Historic Preservation Board

- i. Review of Addition; 100 North Street; Mary Kathryn Connolly & Thomas Doherty, Applicants. Plan Number: HP-00116-2026.

**STAFF MEMORANDUM
HISTORIC PRESERVATION PROGRAM
PLANNING AND URBAN DEVELOPMENT**

TO: Chair Miller and Members of the Historic Preservation Board
FROM: Ashley Molloy, Associate Preservation Planner
DATE: September 10, 2026
RE: 100 North – Public Hearing – New Construction
PROJECT ID: HP-00116-2026
MEETING: September 16, 2026

CONSTRUCTION PLANS

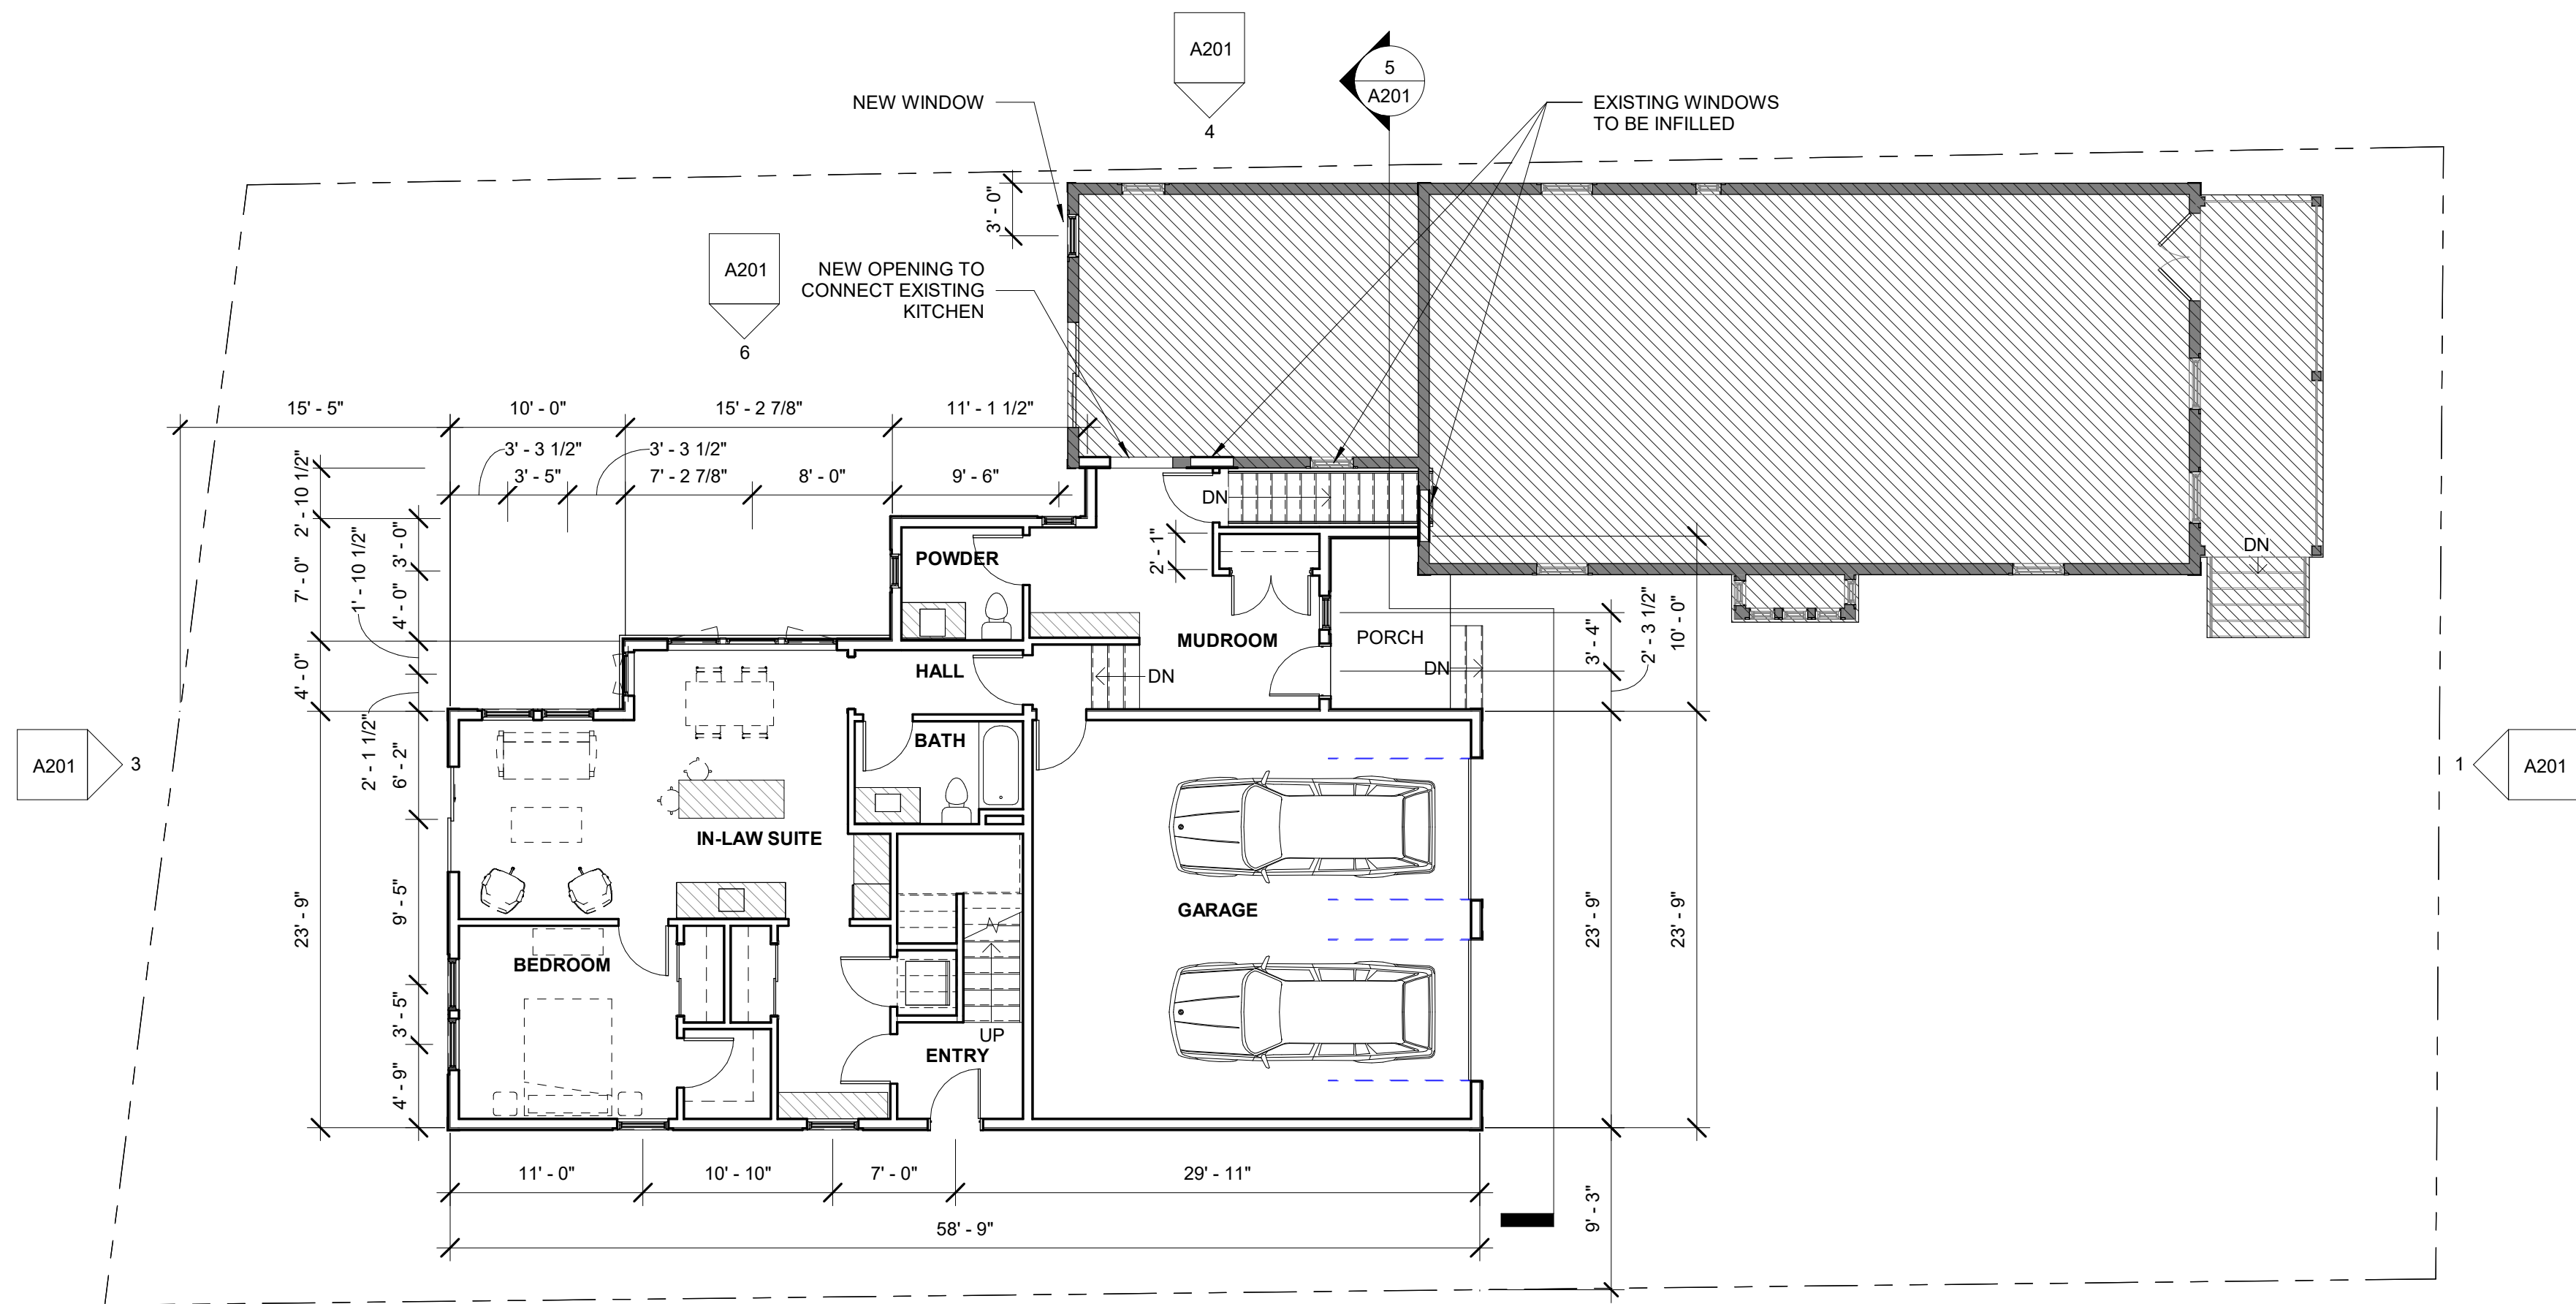
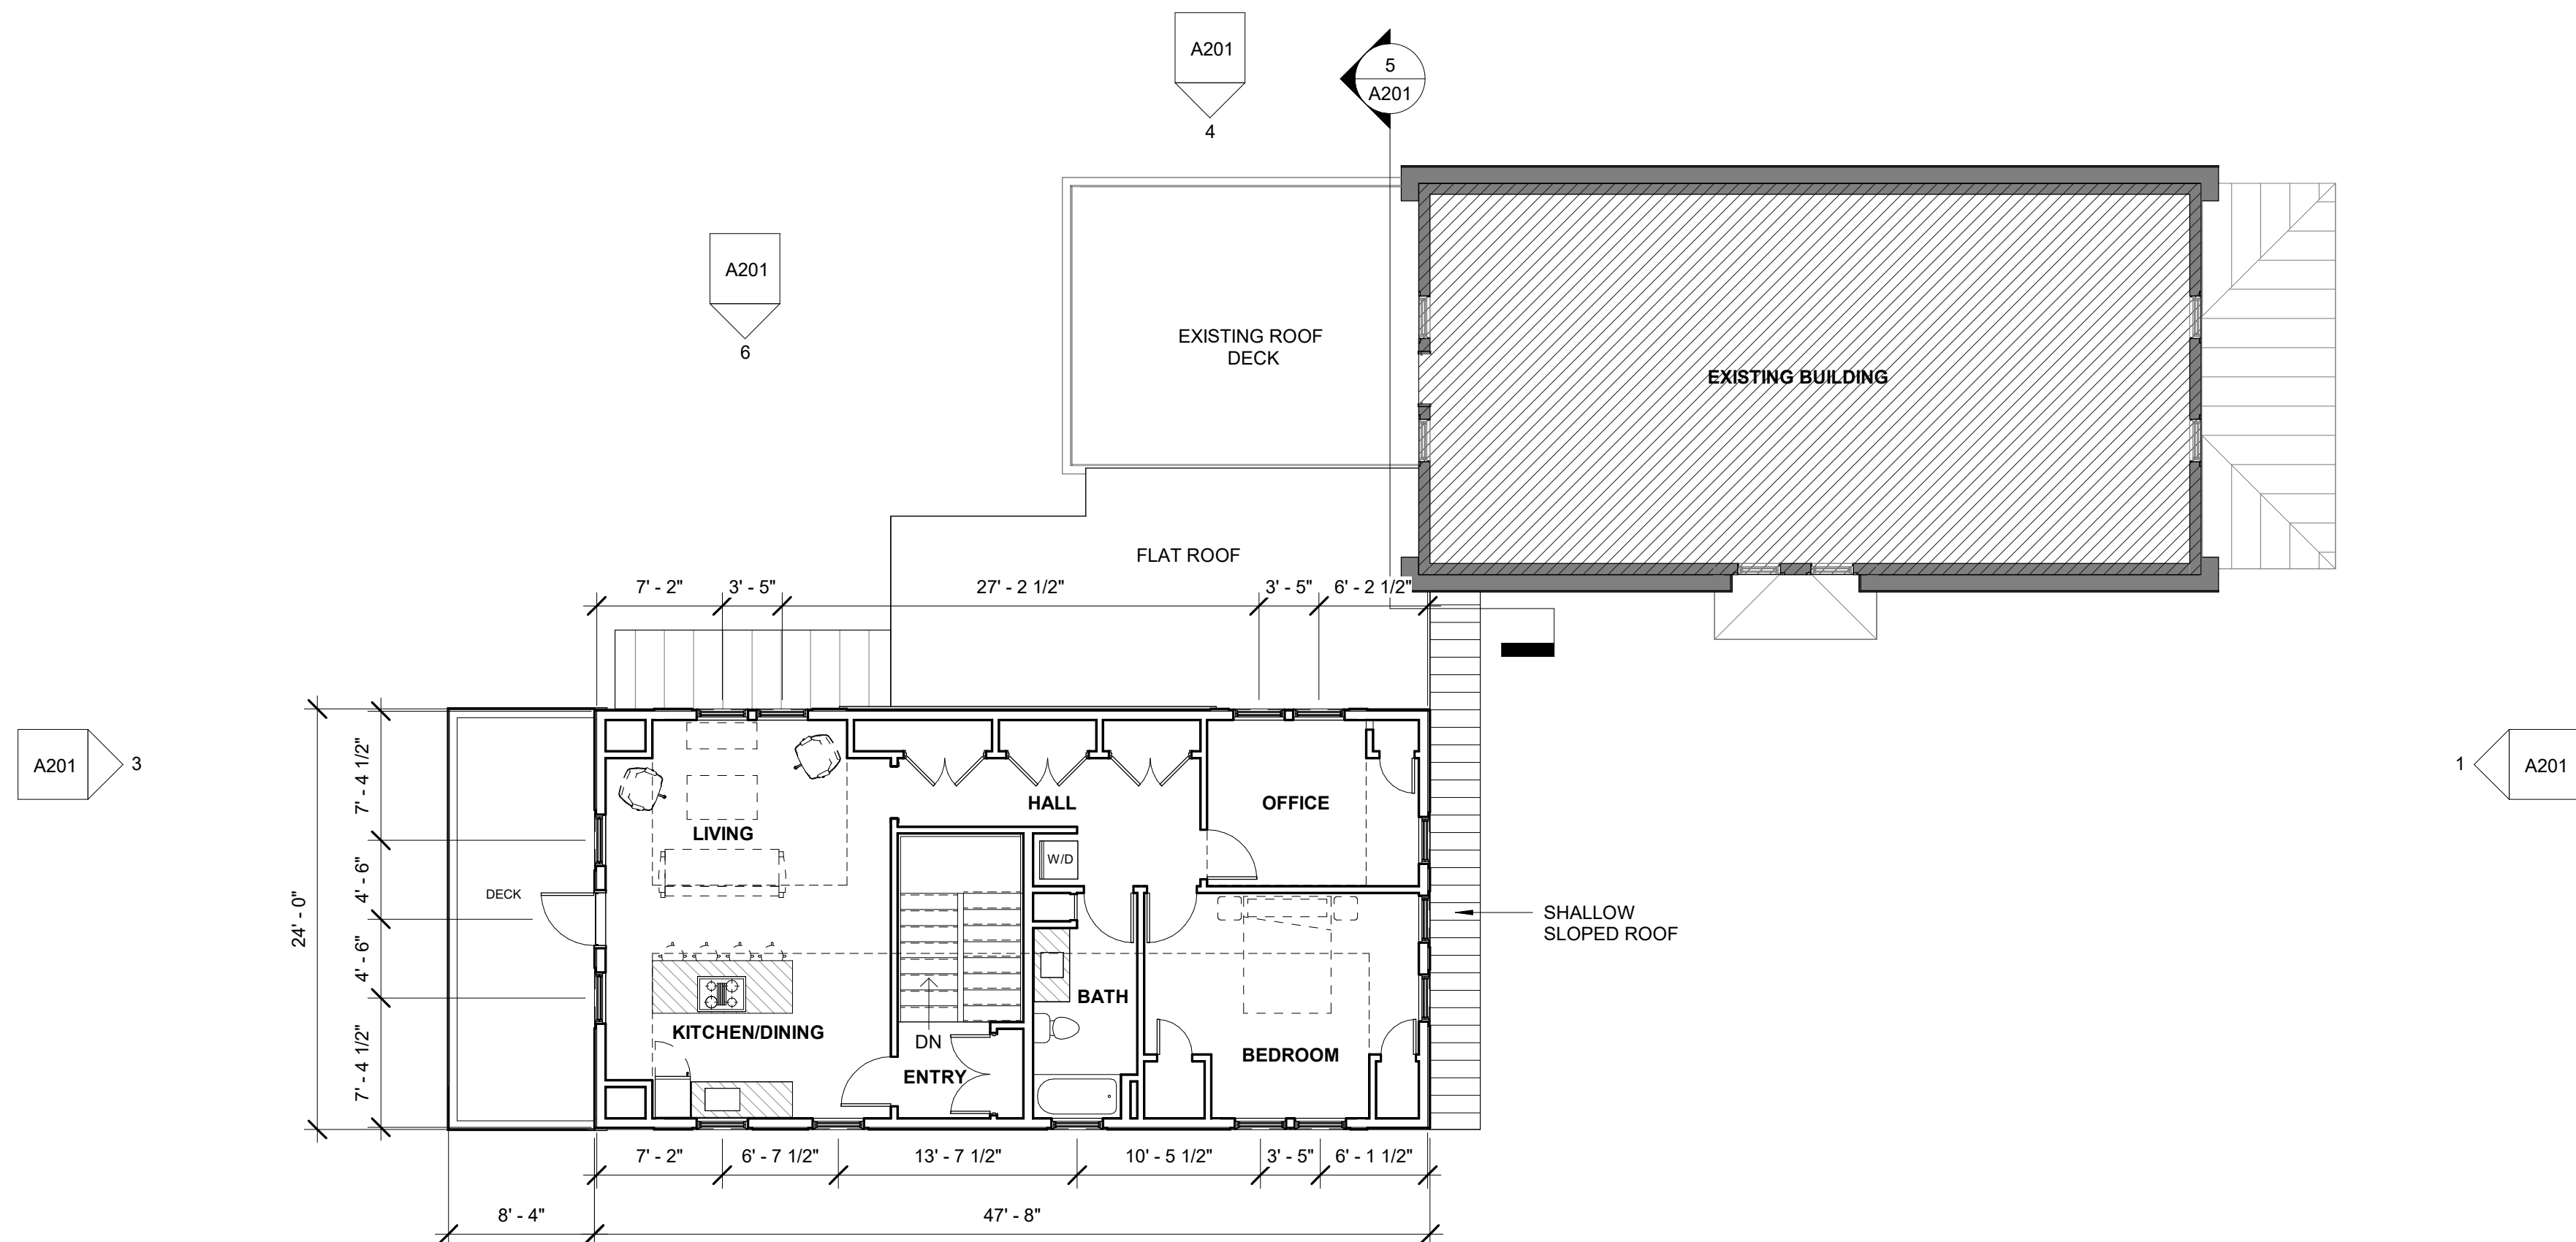
Standard Met?	Staff Comments
YES	The applicant provided plans and a context analysis to demonstrate that the primary mass of the new addition will be about 25 feet wide, excluding the width of the lower mudroom link, and that the existing home is about 24 feet wide. The Board further notes that other residences on North Street, typically range from 20 to 50 feet in width. The Board further finds the addition will match the overall width and form of other accessory buildings and garages in the district which are generally two garage bays wide, and is therefore visually compatible with surrounding structures. Thus, the Board finds this standard has been met.
<u>3. Proportion of principal facades</u> The relationship of the width to the height of the principal facades shall be visually compatible with the contributing buildings, structures, objects, and sites of the historic designation when viewed from any street or public open space.

1 EAST ELEVATION
1/8" = 1'-0"

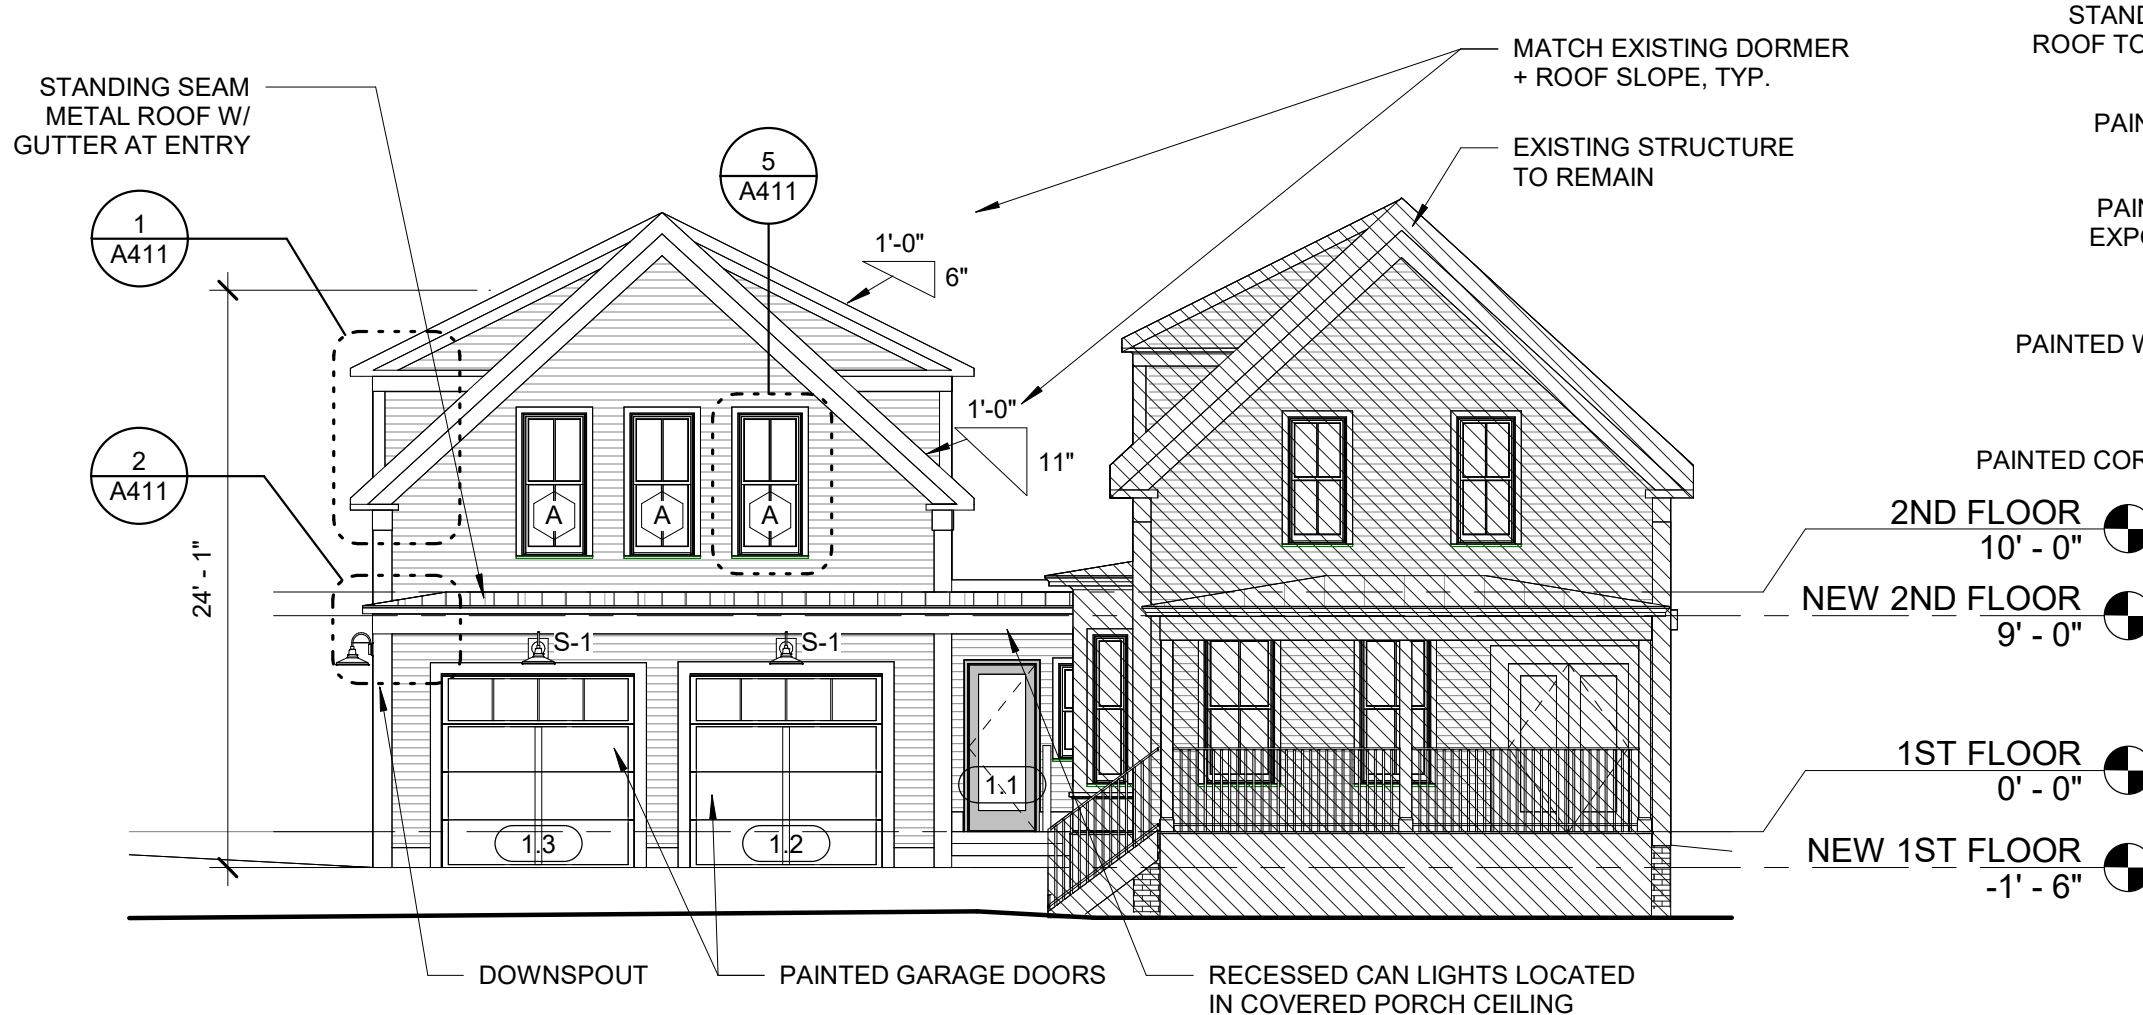
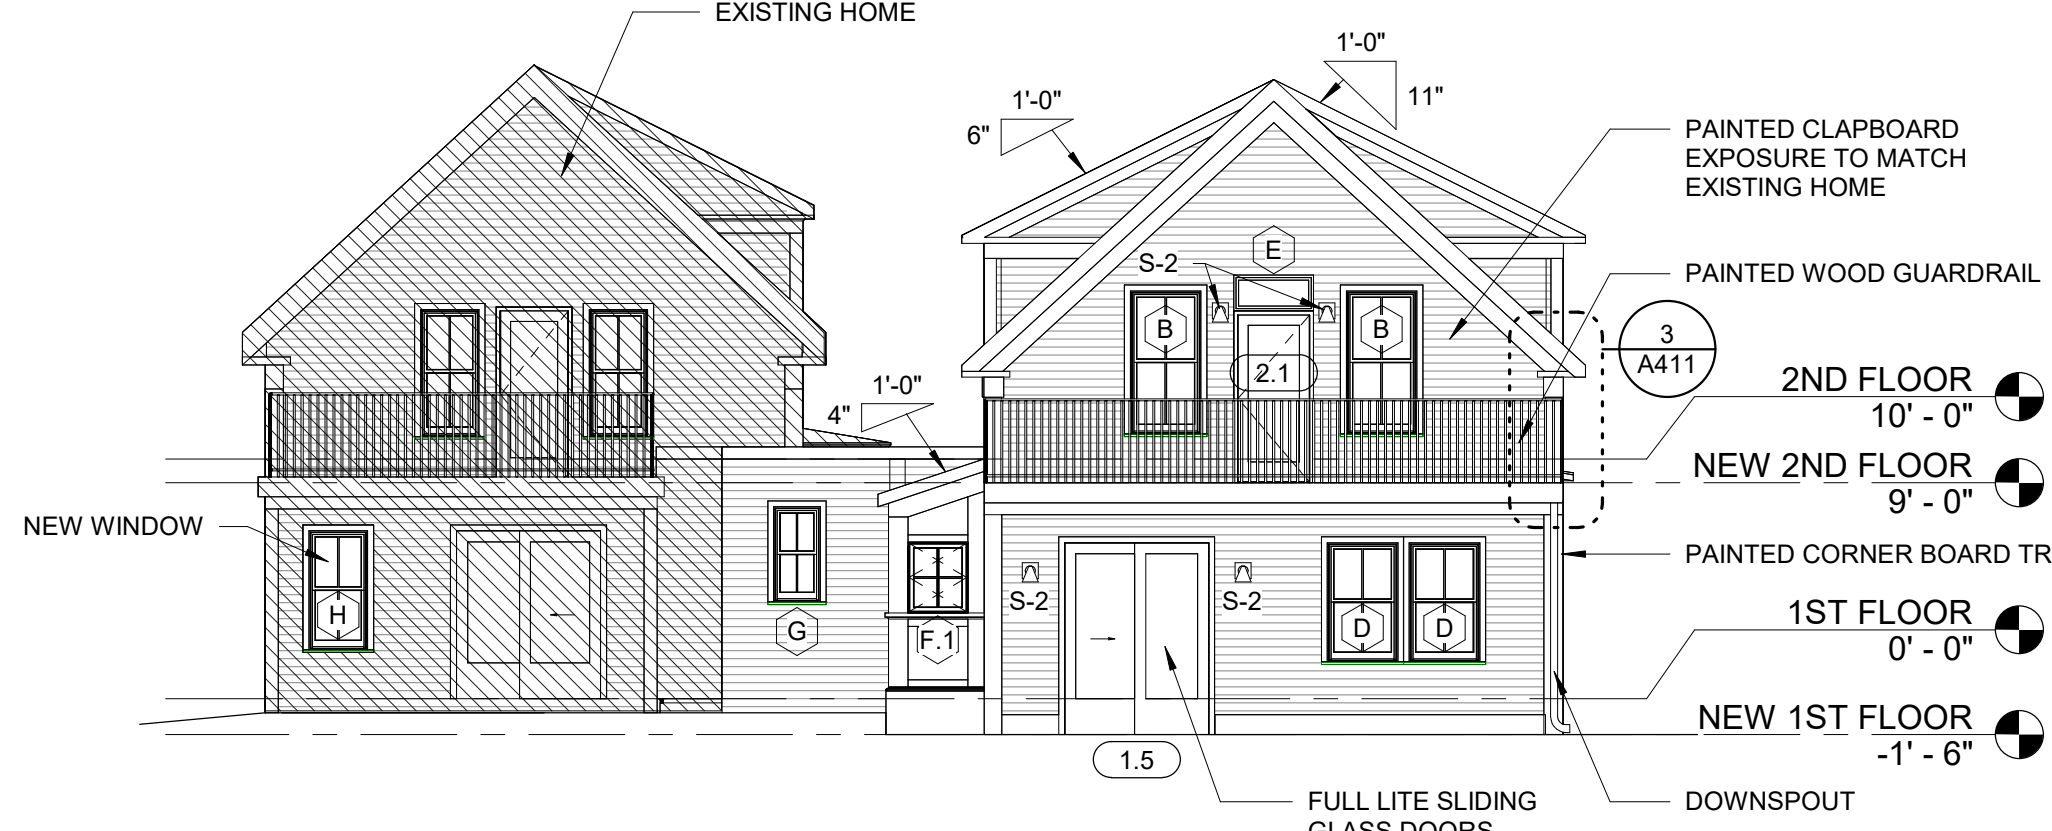
Standard Met?	Staff Comments
YES	The applicant provided plans showing that the existing structure has a generally square proportion, and that the proposed addition will have a somewhat square proportion, both being about as tall as they are wide. The Board finds that the proposed design successfully reiterates these proportions of the existing structure, ensuring visual compatibility. Thus, the Board finds this standard has been met.
<u>4. Roof shape</u> The roof shape of the addition or new construction shall be visually compatible with the
